Project Number: PLN2005-00278 (Pd)

CITY OF FREMONT
FIRE STATION NO. 6
SCHEMATIC DESIGN SUBMITTAL

Exhibit "C"
Findings and Conditions of Approval
Fire Station #6 – Central Avenue (PLN2005-00278)

SITE PLAN

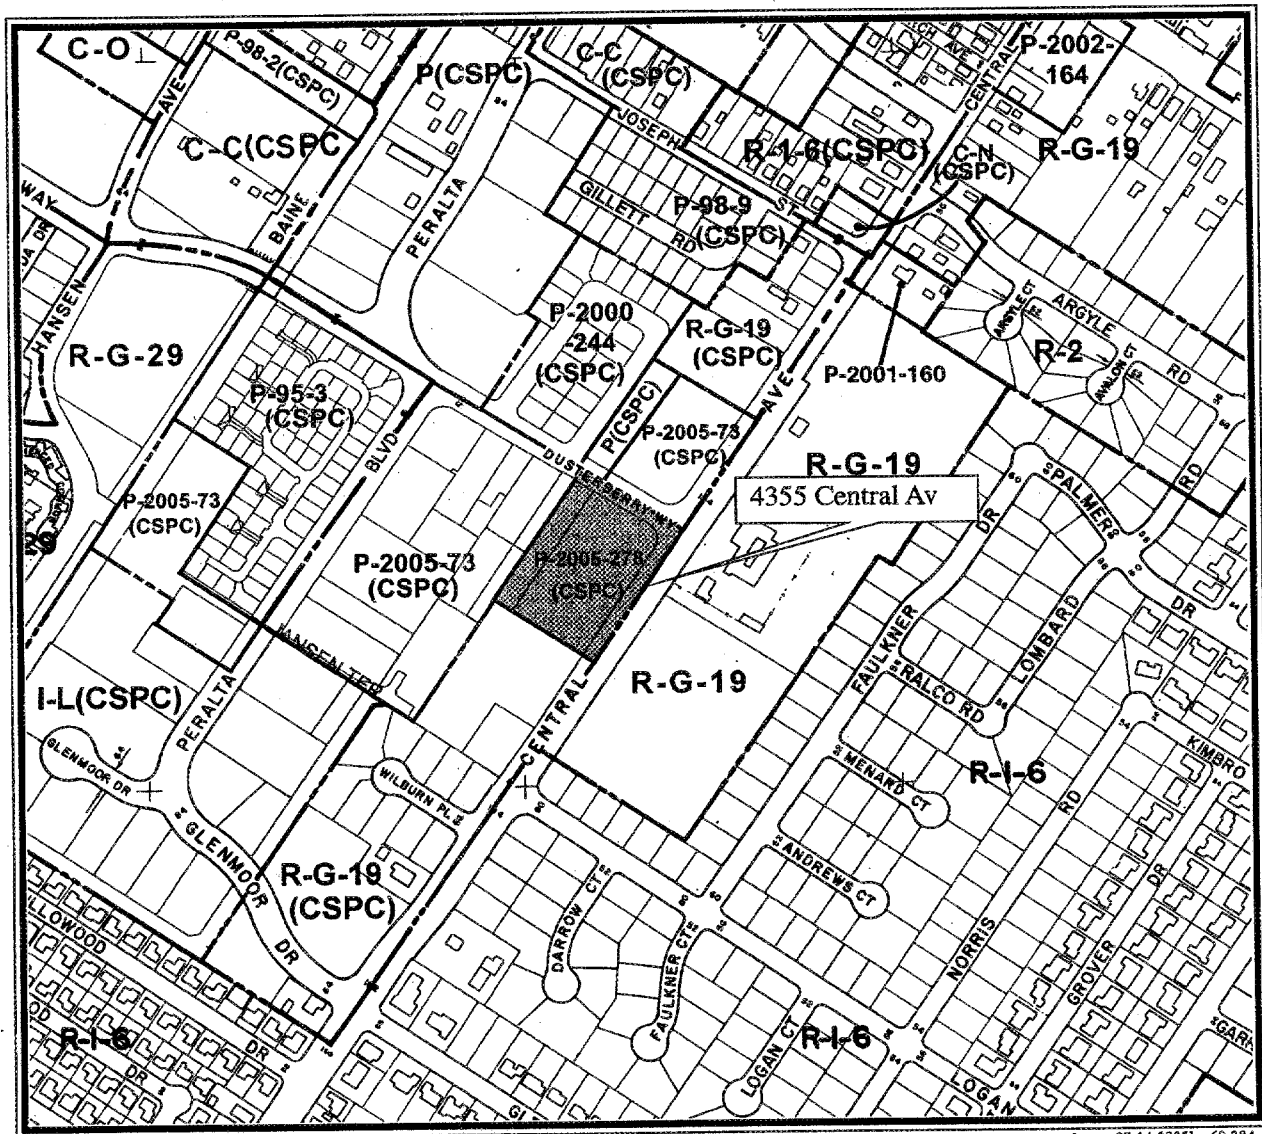
- E-2 The applicant shall provide 2 additional fire hydrants:
- One shall be located shall be at the rear northwest corner of the project using project direction.

- The second shall be just east of the southwest driveway. This hydrant may be either on site or public.
- E-3 The applicant shall increase the lateral connection, detector check valve and fire under ground service to 8 inches. It then may be reduced to 6 inch when there is a single hydrant to be supplied.

- E-4 The applicant shall increase the driveway width between the reserve apparatus storage building and the parking stall to at least 20 feet; 24 feet is preferred.

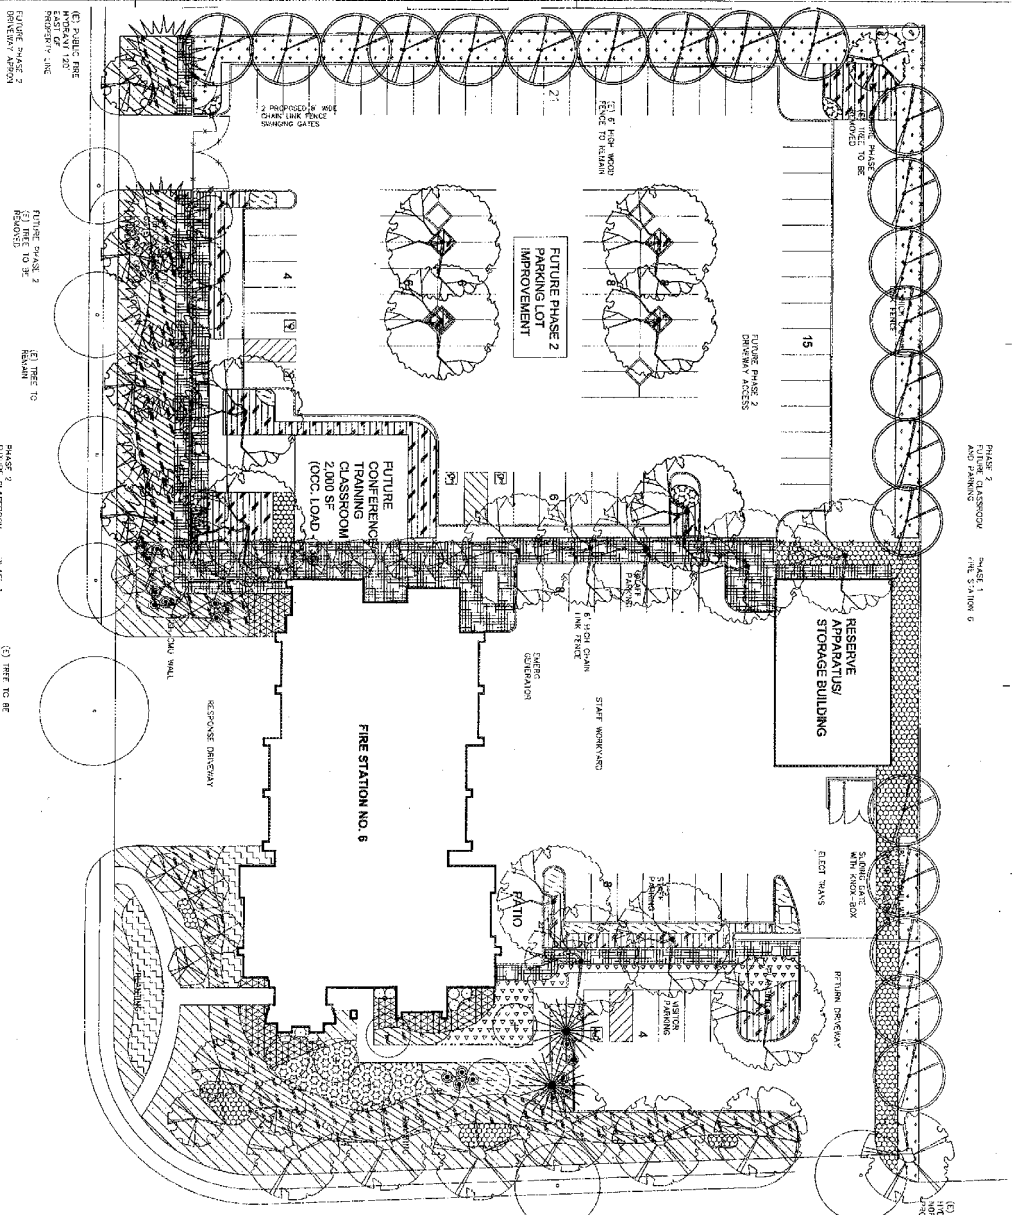
- D-1 Removal of street trees for the construction of driveways shall be mitigated by the planting of onsite and offsite trees. Tree species, quantity and size shall be determined upon discussion with staff and with the City's Maintenance Division.
- D-2 Clearly demarcate the extent of Phase I. The current work shall be complete onto itself in that it is clearly separated from the Phase II work. There shall be no open or unfinished planting areas dependent on Phase II work.

- D-8 Submit a complete Tree Survey that conforms to the LDRP pages 4-8 (Identify trees with a brief description of its condition). In addition to the onsite trees, there are a number of City street trees that should be included in the Tree Survey. Include the Magnolias on Central that may have been previously topped by PG&E, as well as trees on Dusterberry.
